AUBURN HILLS 5TH ADDITION

Re: S/D97-84 -- Final Plat of AUBURN HILLS 5TH ADDITION

STAFF REPORT

CASE NUMBER: S/D 97-84 AUBURN HILLS 5TH ADDITION

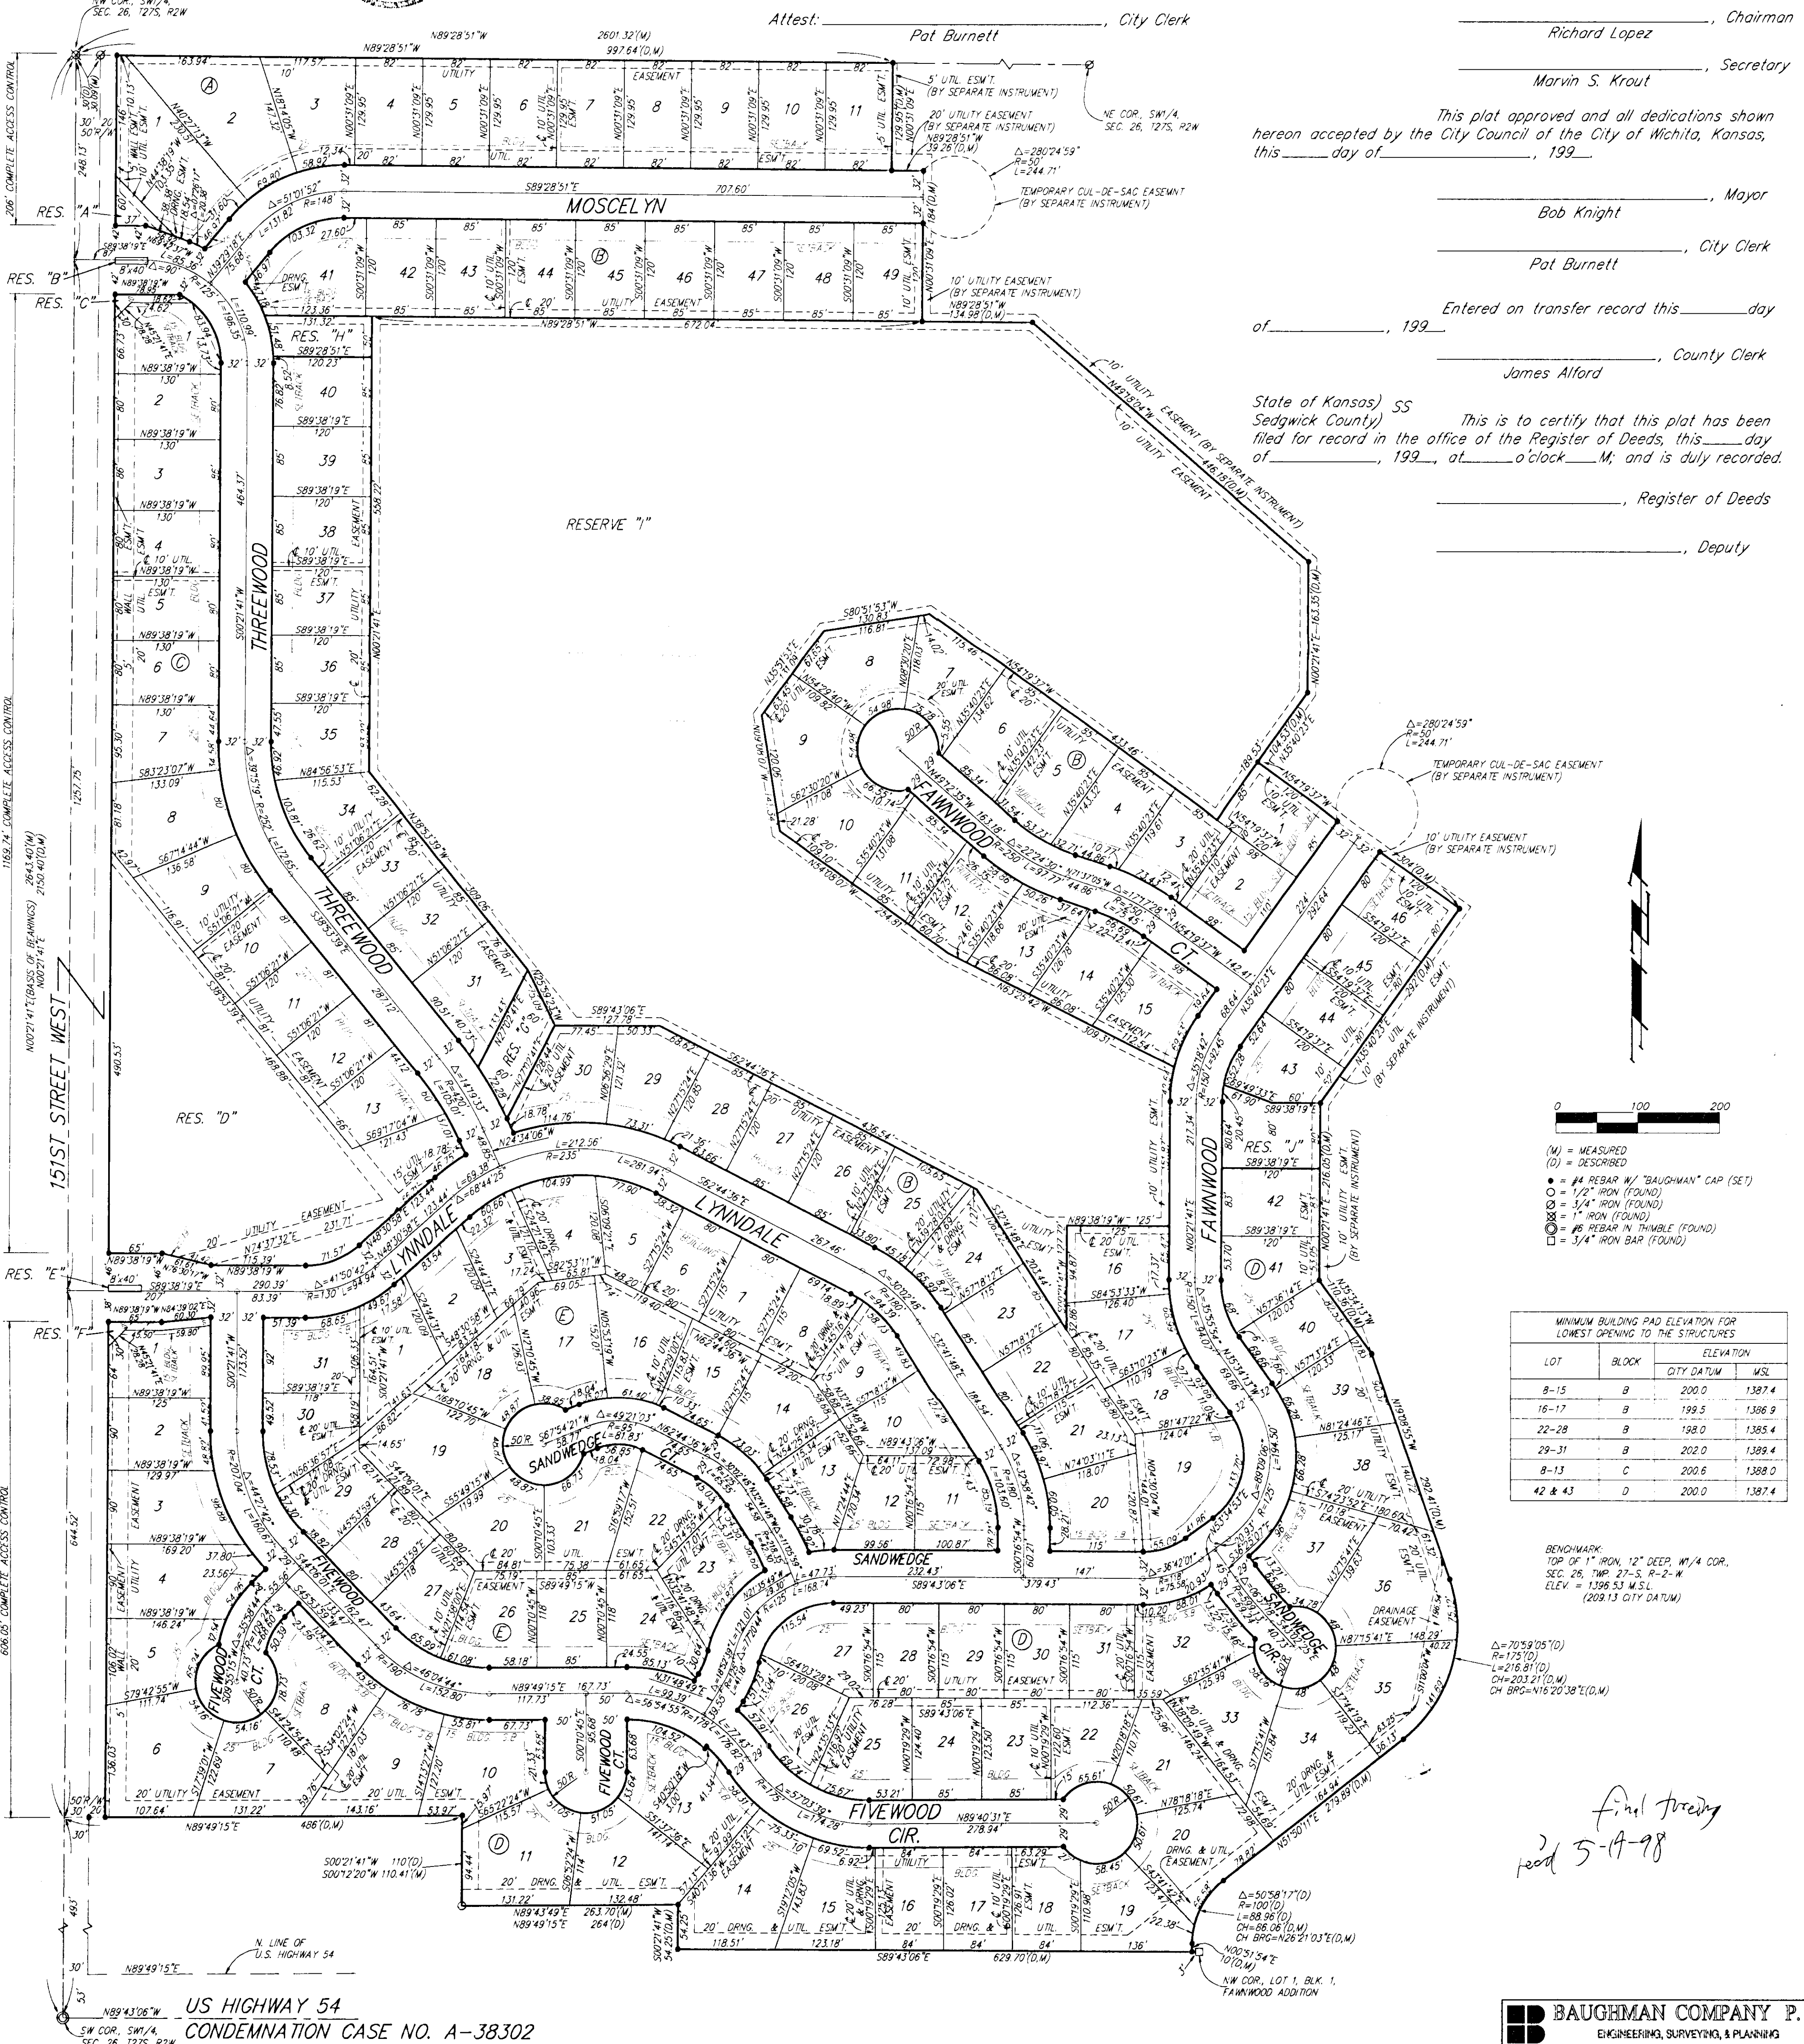
- E. A street stub to the north of this plat should be shown for connection to potential future development.

- F. Distances should be shown for all segments of access control. On the final plat tracing, since the site will be within Wichita City limits upon annexation, the platlor's text shall note that the access controls are being dedicated to the "City of Wichita".

- I. The applicant needs to revise the legal description on the face of the plat to accurately portray the land being platted. The distances and degrees adjoining lots 11 and 12 on the southern line of the property need to be included in the platlor's text. In addition, several southern bearings on the face of the plat need to be corrected to reflect northern bearings as identified in the legal description.

- J. Temporary turnarounds will be needed for the terminus of Fawnwood and Onewood Streets. On the final plat, the area for temporary turnarounds should be shown with dashed lines around the area of the actual street.

The platlor's text should indicate that the temporary turnaround areas will automatically be vacated upon the extension of the streets.

The KG&E representative requested a 10-foot utility easement adjoining the right-of-way between Lots 15 and 16 in Block B which has not been denoted on the final plat.

The final plat does not indicate the street stub to the north, as requested during preliminary plat review. However, the preliminary plat submitted for Auburn Hills 6th Addition indicates a street stub to the north adjoining the northeast corner of this plat.

KGE has requested additional easements as denoted on the attached plats.
